**Subject: Cell 4 – Green-Croissant Pit  
Reclamation Slope Evaluation Version 2**

- Corrects typos, and mis-interpretation of the Rule to address comments by DRMS (Hays, 2022)
- Summarizes our evaluation of the existing reclamation slopes at the above referenced mine cell
- Compares our analysis to that provided by Ms. McGill (McGill, 2021)
- Evaluates the Division of Reclamation, Mining and Safety's (DRMS's) correspondence intimating a regrade requirement of Zones 9, 20, 25, 26 and part of 27 (Hays, 2021)

**Figure 2 Slope Evaluation at King's Maximum Indicated Slope**

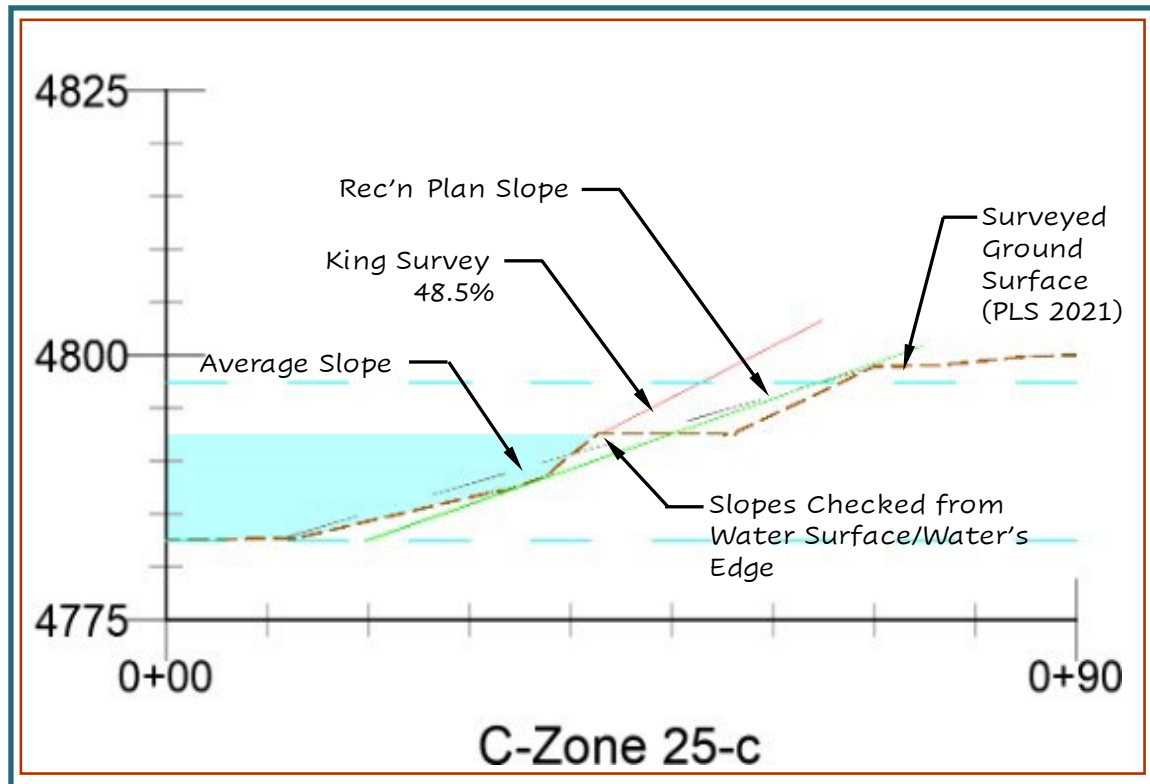
Zone 25-c<sup>2</sup> in Sheet 2 is near King's indicated 48.5% slope (2:06H:1V), which, from visual inspection, is their common result in Zone 25. Figure 2 shows the evaluation of the slopes at King's indicated average. It could be that when the King survey was completed, the water level was 0.5 to 1 foot higher as shown in Figure 3. Regardless if one examines the section as in Figure 2 or Figure 3, the average overall slope from crest to toe is 3.61H:1V (grey dashed line in figures), meeting compliance with the reclamation plan.

**Figure 3 Potential Conditions During King Survey**

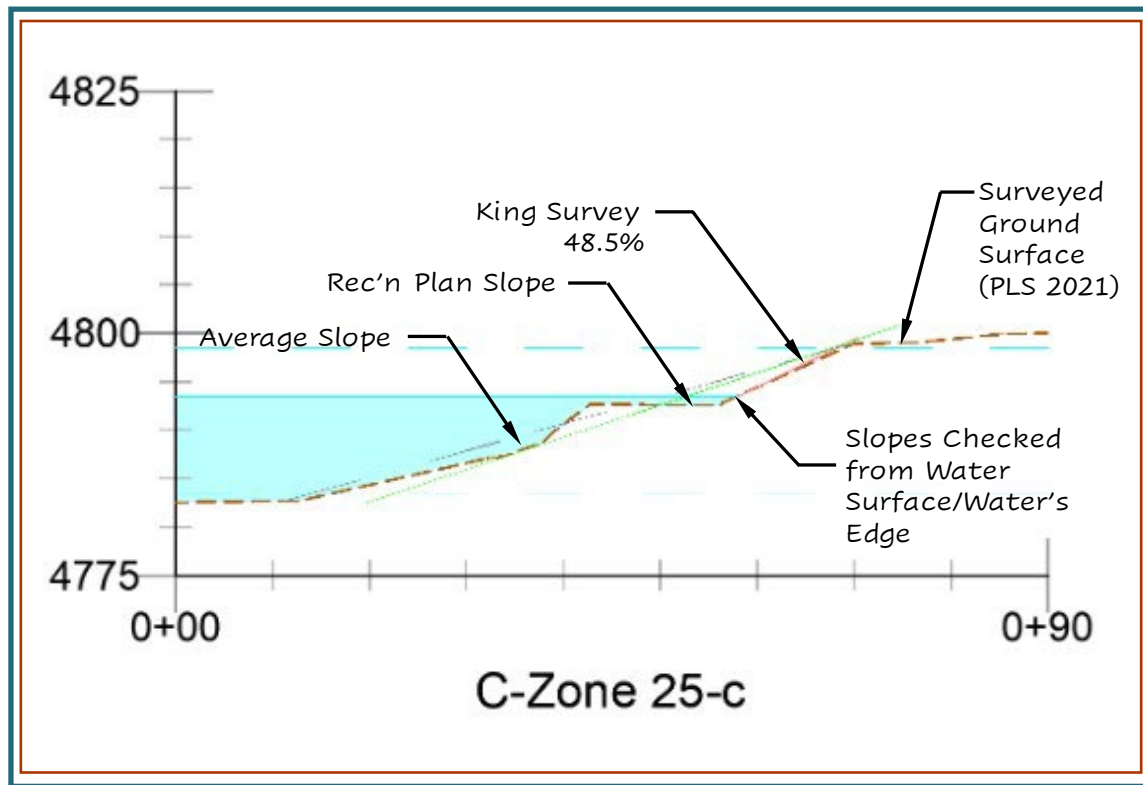
The cross section shown in Figures 3 and 4 (and others shown in Sheet 1) result from erosion at the water's edge, which is a very natural occurrence in ponds along the Front Range as previously mentioned. Wave action erodes some of the bank above the water level, and deposits sediments immediately below the water surface, resulting in a "bench" and irregularities in the slope (Figure 5). Sometimes a high groundwater table helps exacerbate the problem (as is the case on the west side of Pit 4). We know that the walls of Pit 4 met slope requirements at the time of closure, and the slopes were "smooth" as indicated by:

The intent of the Rule is to ensure that during mining and reclamation that the constructed banks are stable. After filling with water, the pond is in a post-reclamation state and it does not appear that the rule is intended for long-term maintenance of the banks. Regardless, the resulting bench from the erosional process and vegetation of the slopes ensures that the bank remains stable even in the post-reclamation state.

**Figure 4 National Agricultural Imagery Program (NAIP) October 2017**

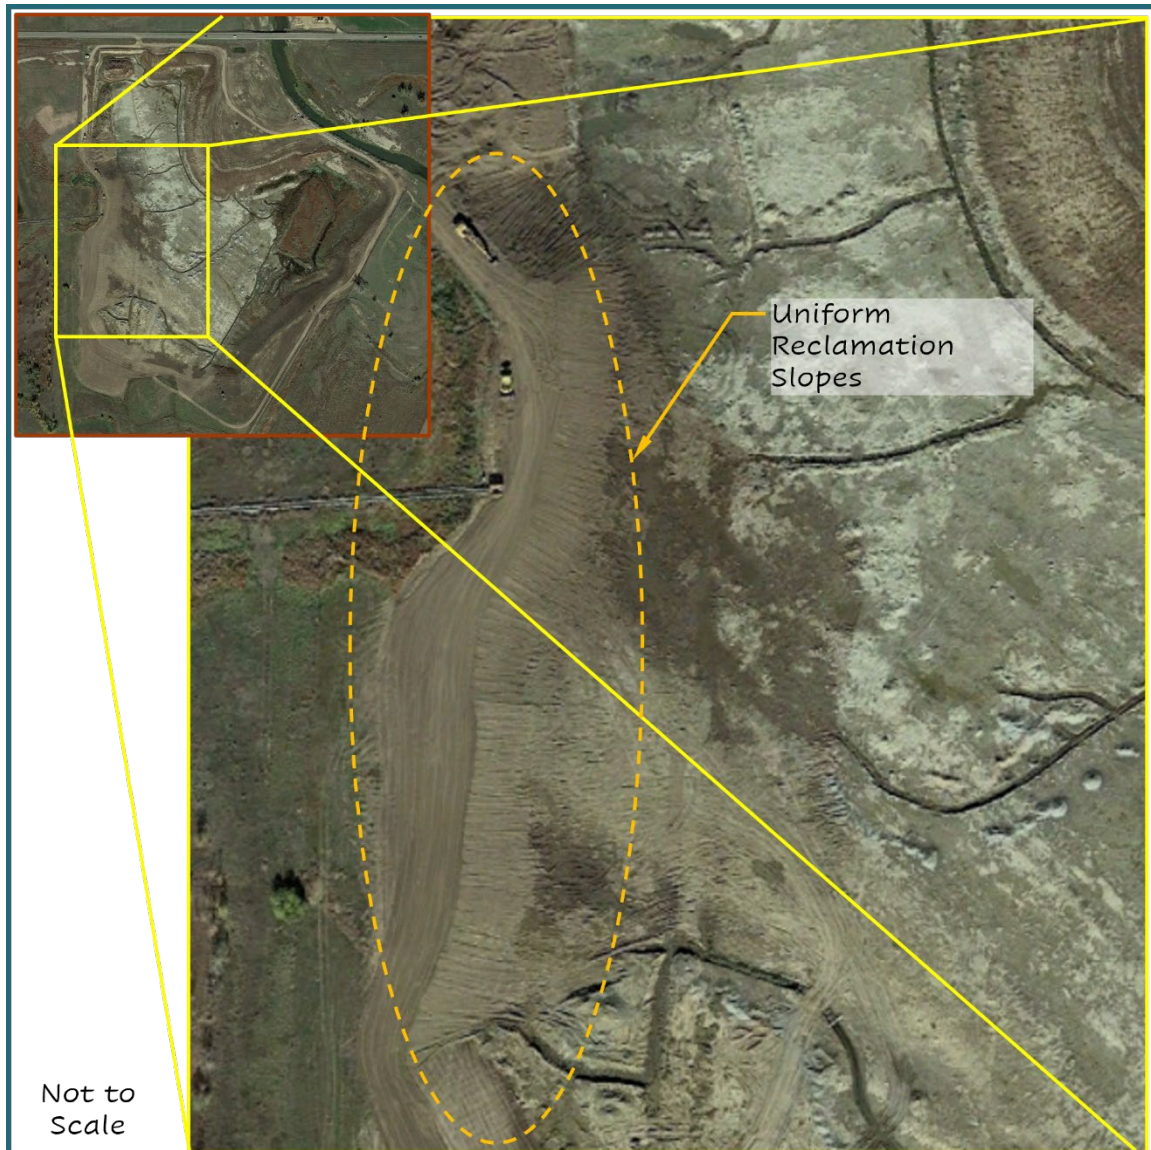
- Recollection of reclamation (Fancher, 2021)
- An aerial photograph dated October 2017 (USGS, 2021), displayed in Figure 4
- Topographical survey of the above water level bank 1/2/2019 (CDS, 2019) as summarized in Attachment 4
